# ADDENDUM No. 1

### 2013 ROAD PROGRAM

# CLARKS LANDING ROAD/BLACK POINT ROAD

# TOWN OF MOULTONBOROUGH, NEW HAMPSHIRE

#### SHEET NO. SK-1

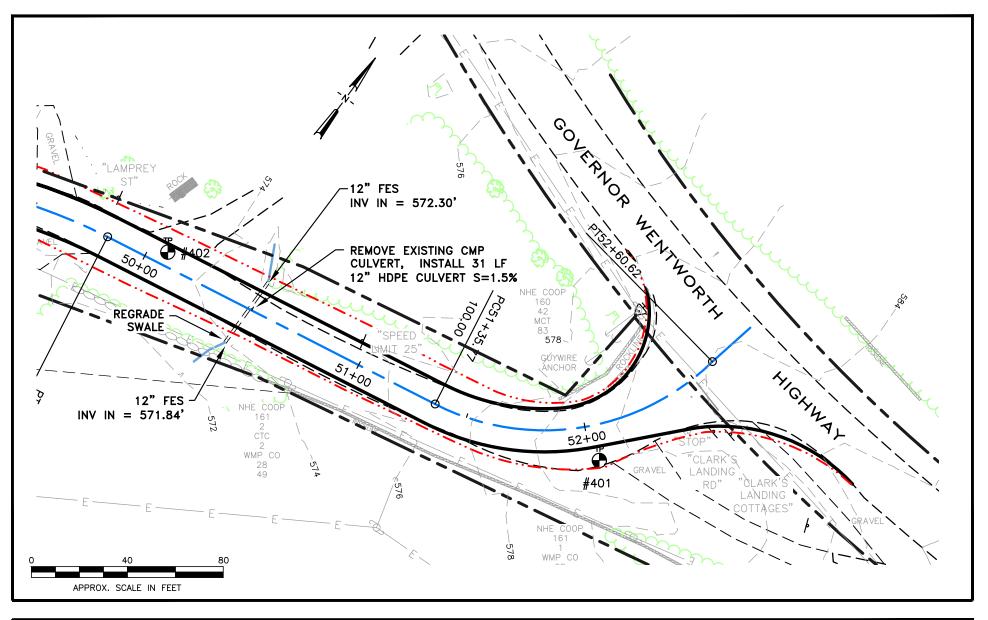
A. Add Drawing SK-1 entitled 12" HDPE CULVERT-STA 50+50.
